ADDENDUM NO. 1

WATER TREATMENT PLANT REPLACEMENT

VILLAGE OF RICHWOOD, OHIO

Project No. 220851.01

CLEARWELL

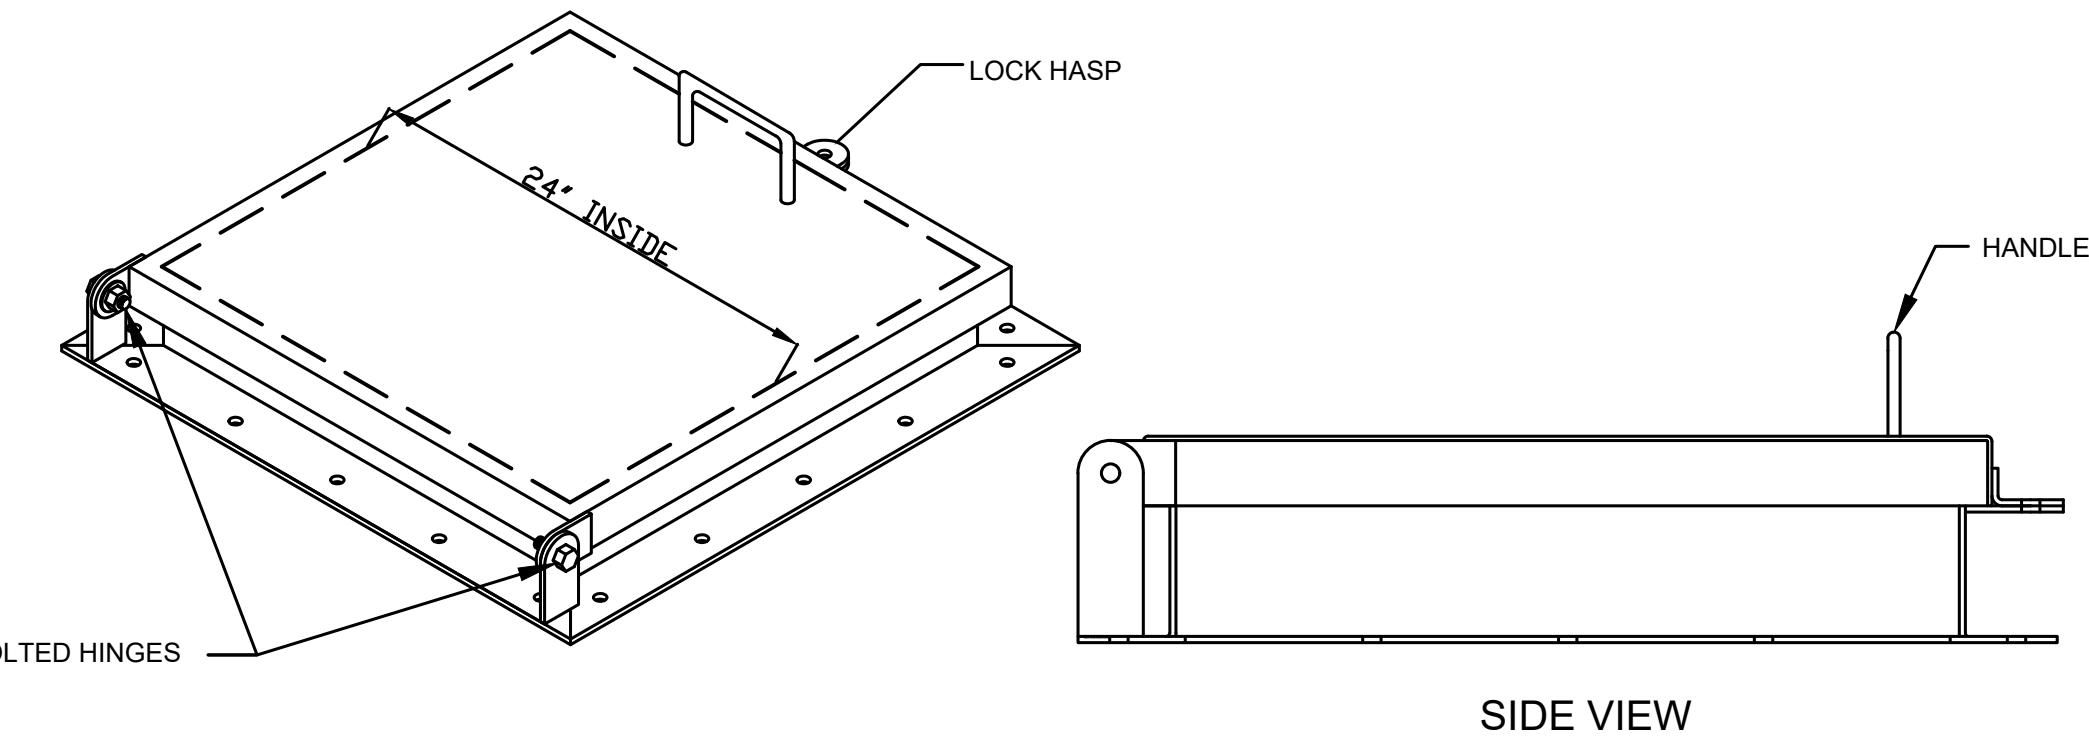
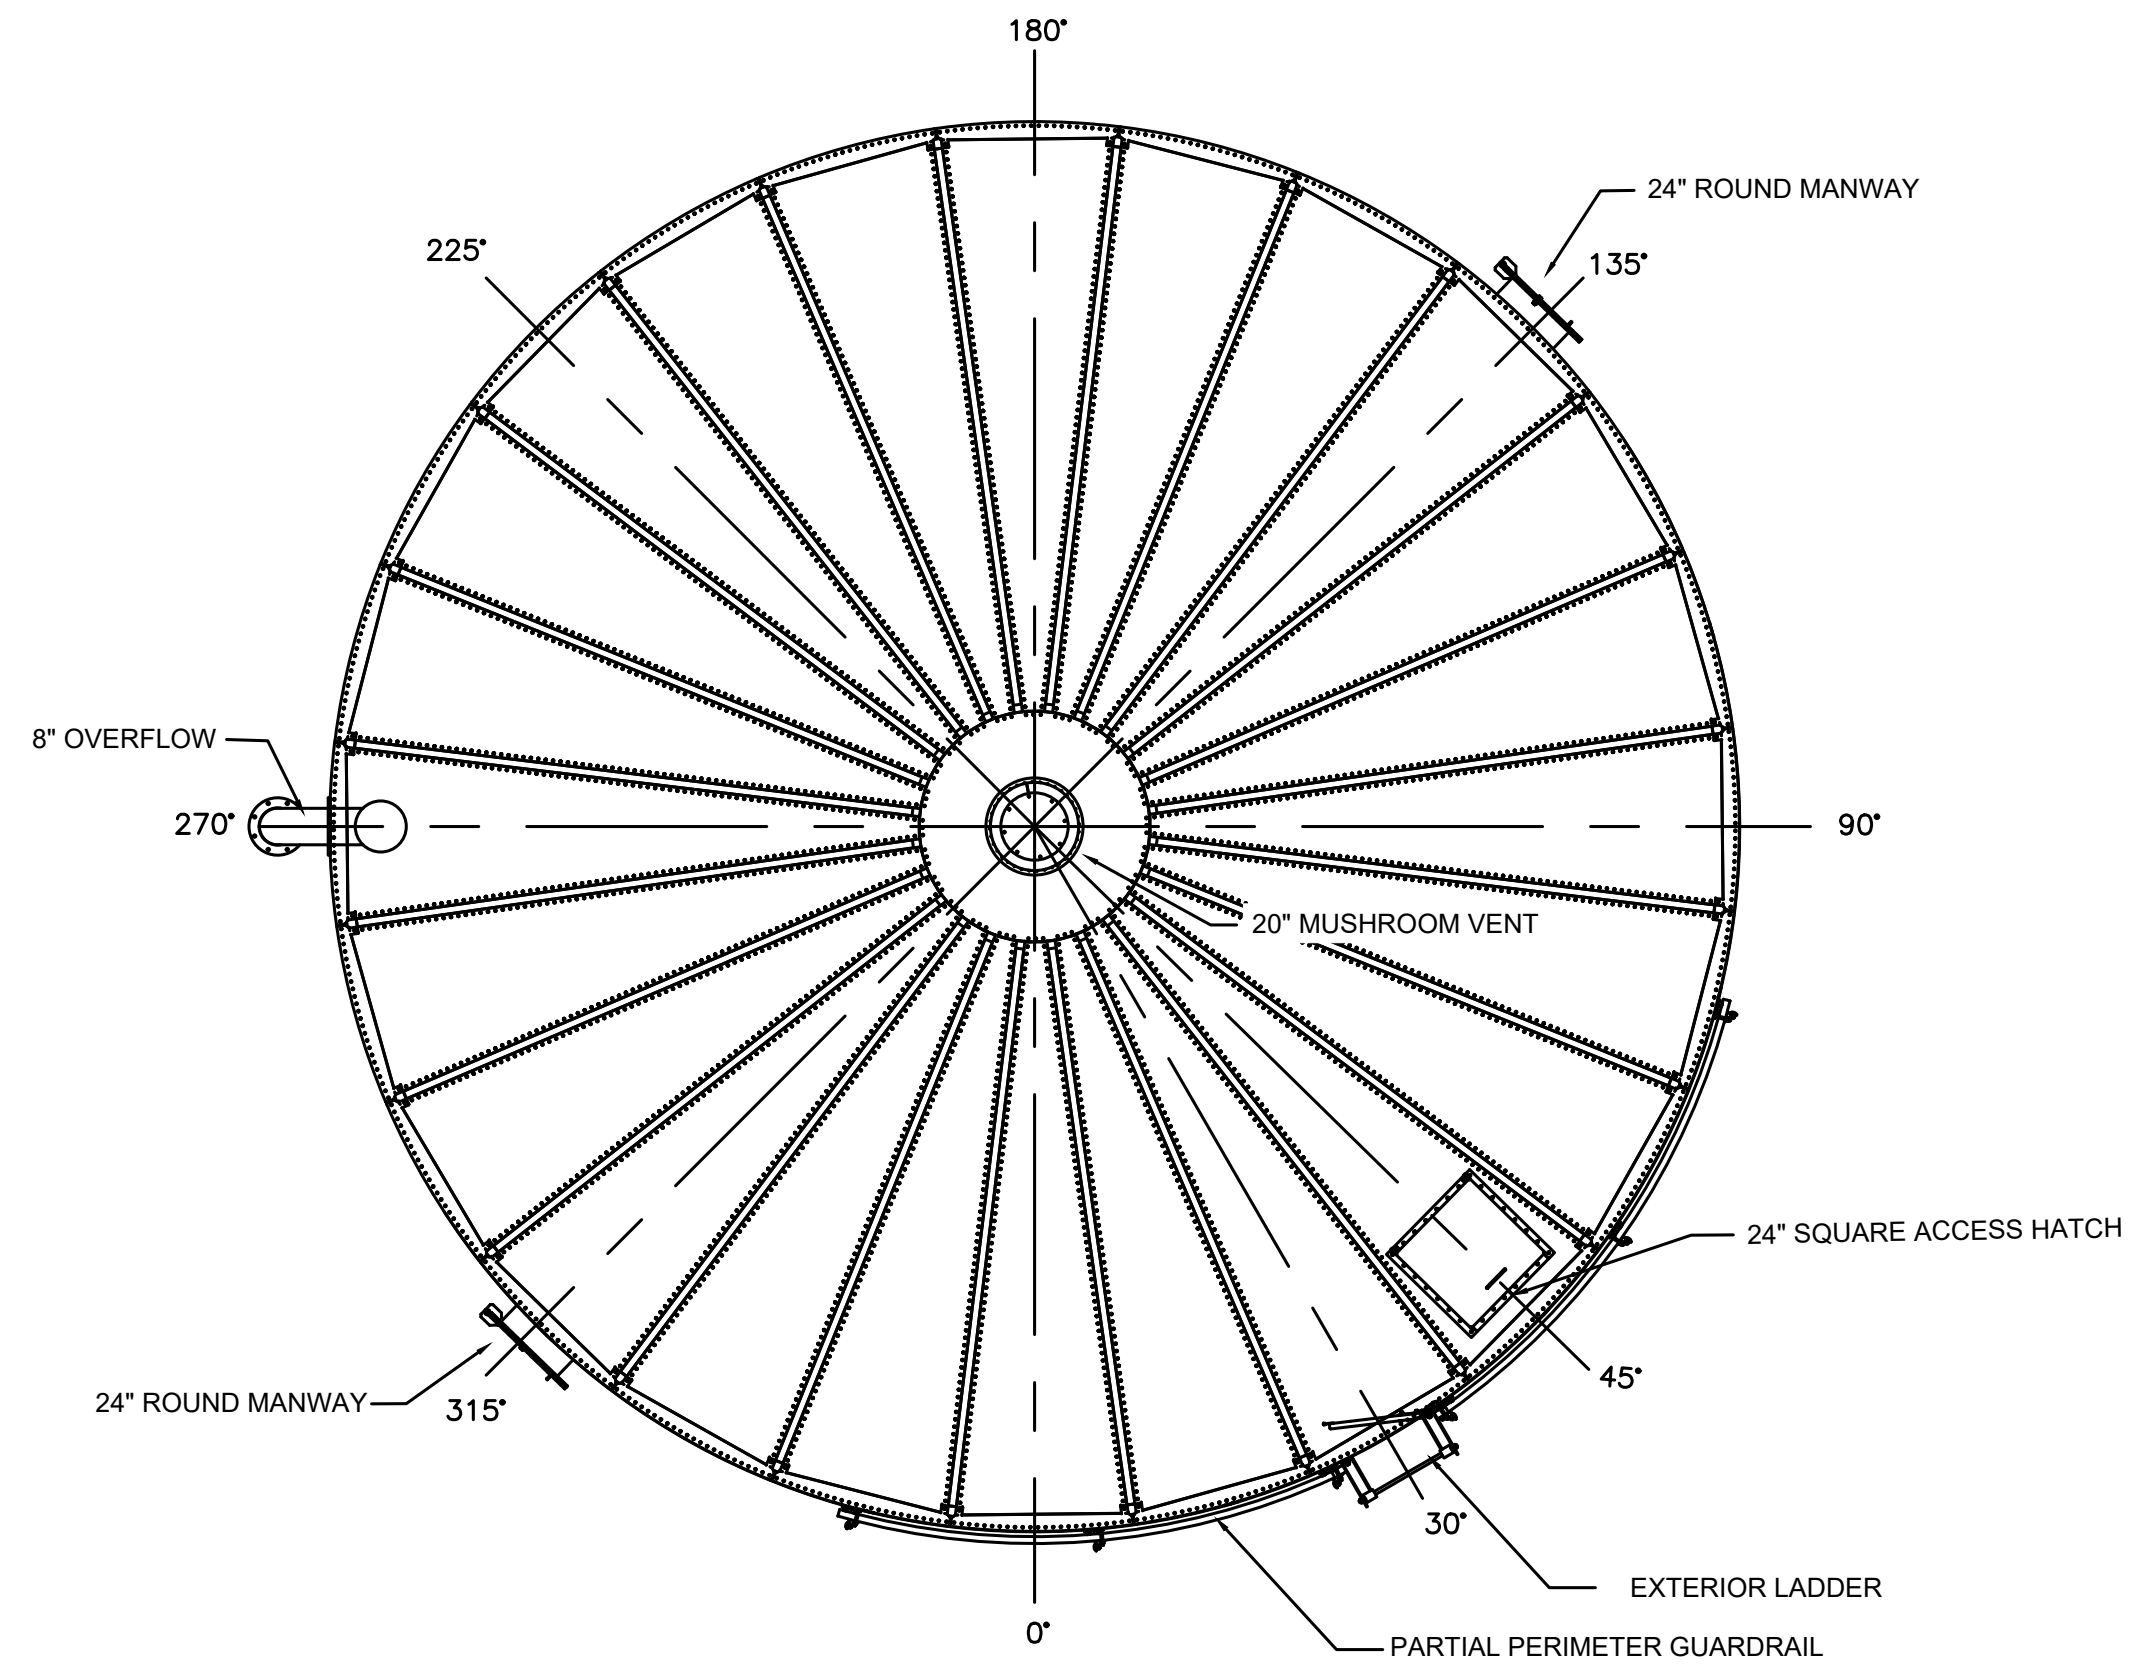
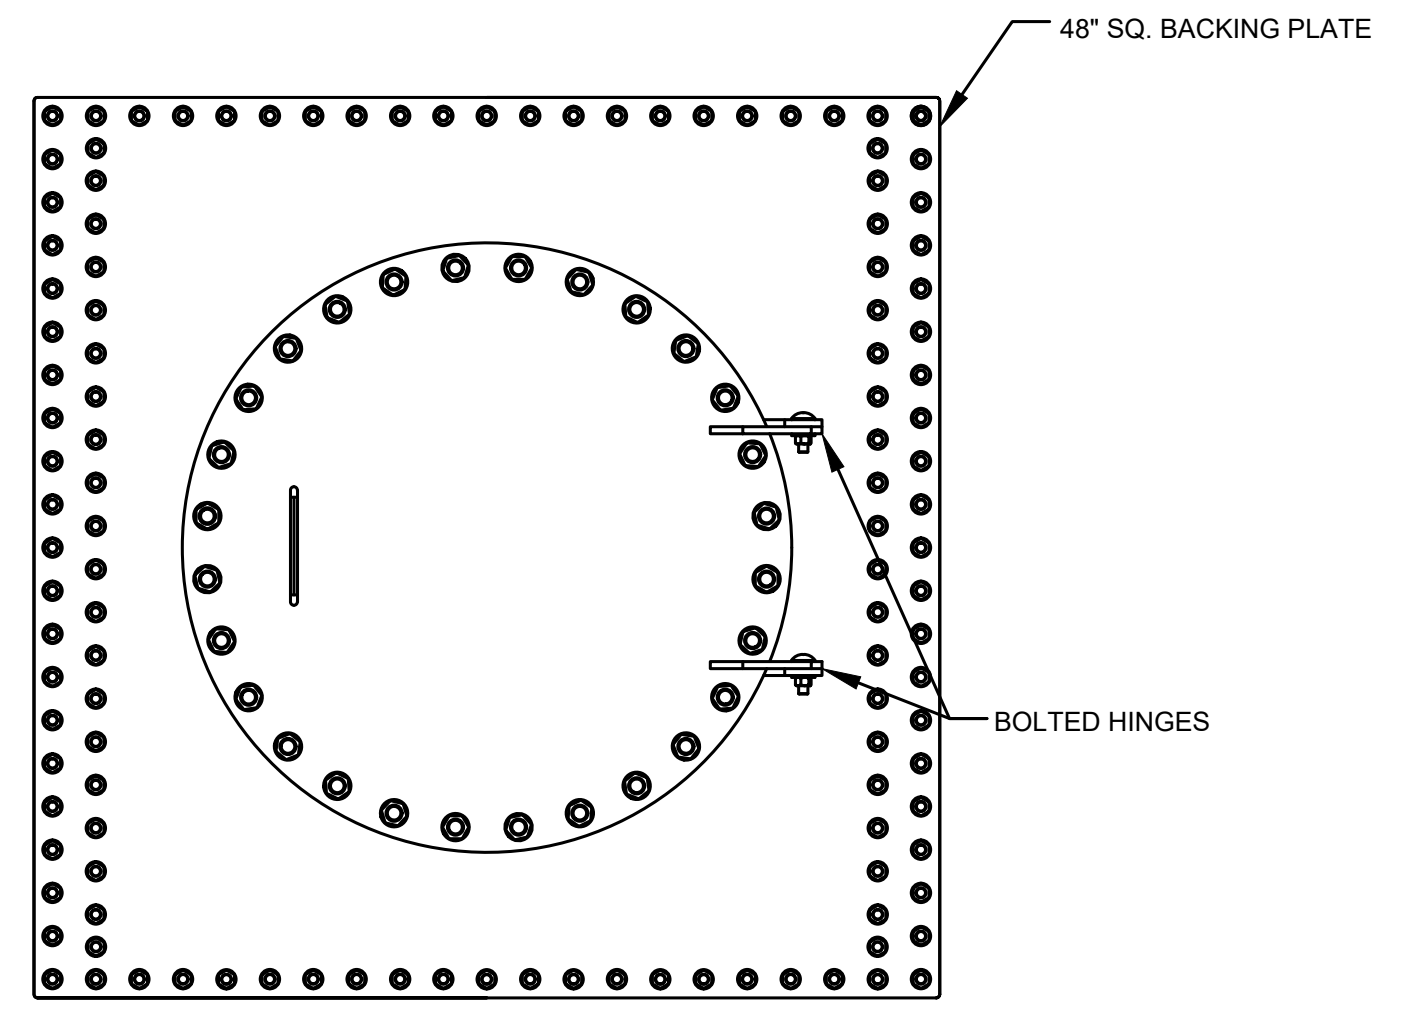
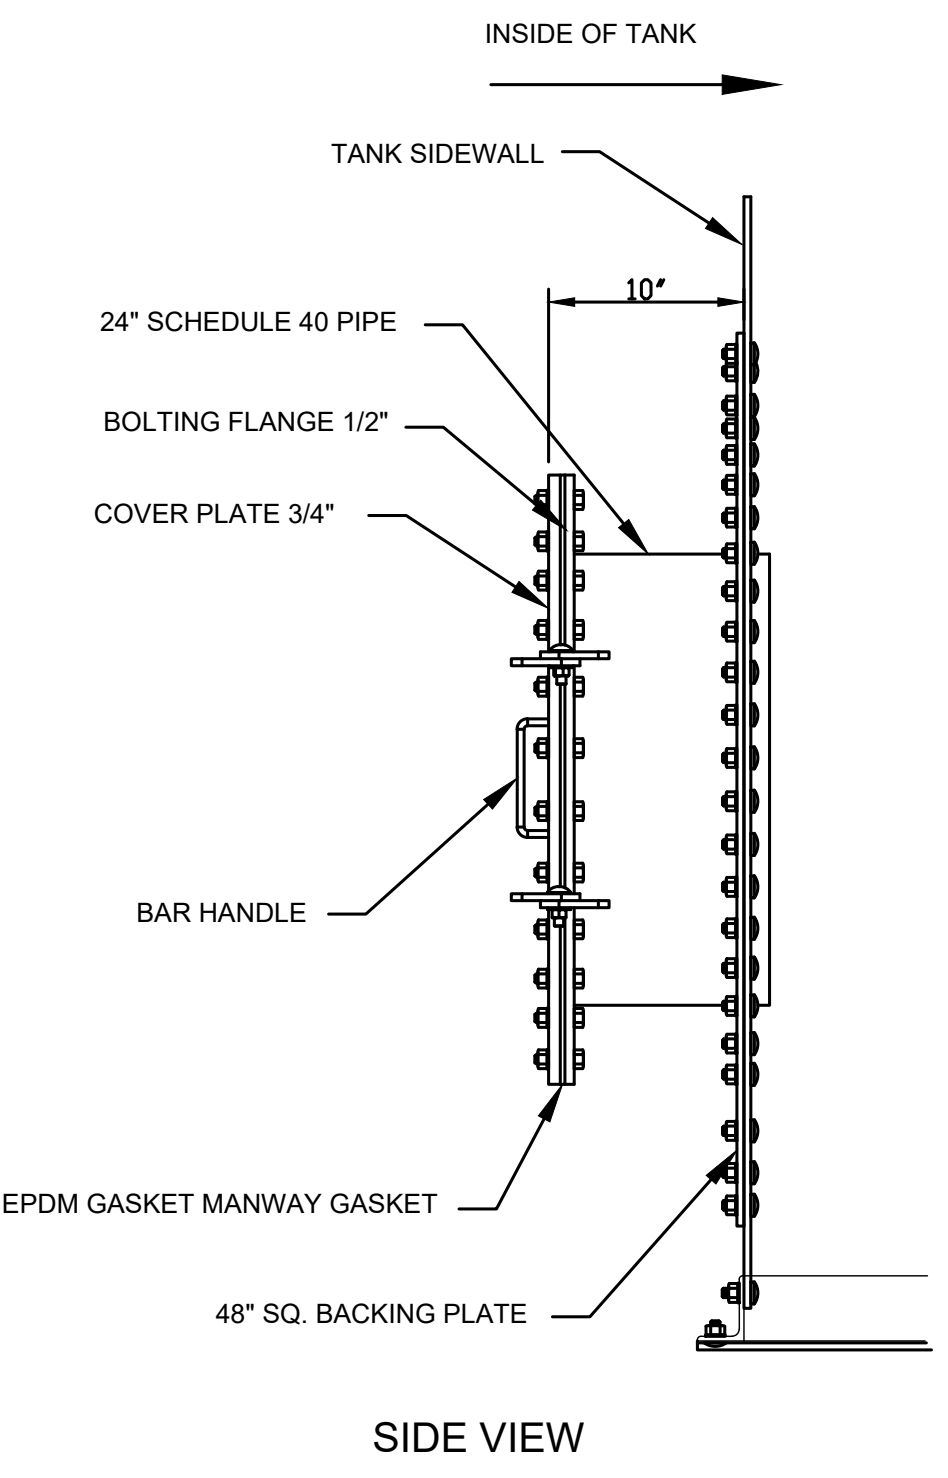
- a. The clearwell drawings shall be replaced in their entirety with the attached drawing numbers: 32A, 32B, and 33. The drawings have been modified to allow the inlet and outlet piping to pass thru a concrete floor rather than the sidewall of the tank as originally shown on the drawings.
